**MEMORANDUM**

SUBJECT: **BZA Case 18696** – Request for variance relief to allow construction of a rear deck at the first floor level of an existing two-story row dwelling located at 1431 Parkwood Place NW

CASE NO. 18696

EXHIBIT NO. 27

Figure 2

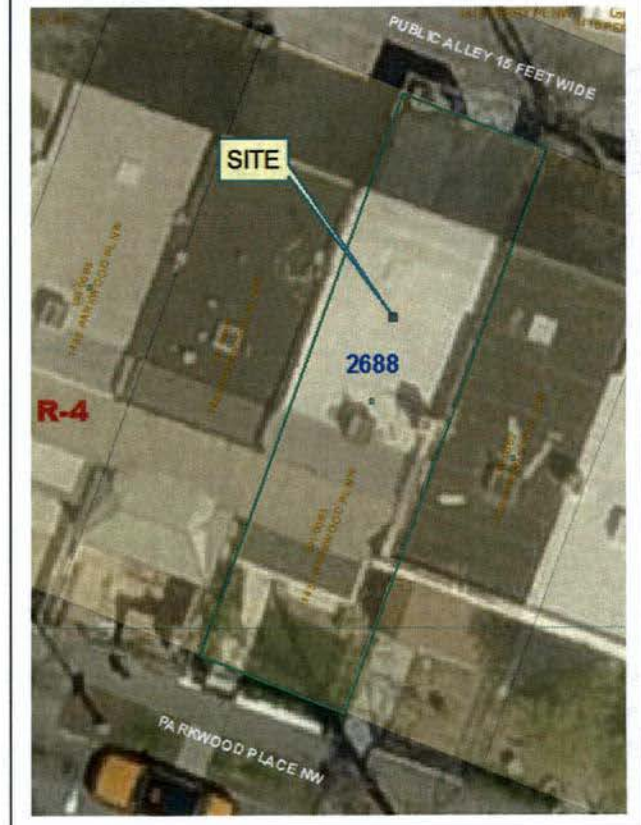
However, the subject property to be one of at least ten subdivision lots developed with the same site characteristics including the shallow rear yard dimension and basement garage with driveway access to the alley (reference Exhibits 1 and 2). The subject property is therefore not unique. In fact the neighboring property to the west at 1433 Parkwood Place shares many of the same limitations including a Juliette balcony (also reference the photographs submitted with the application).
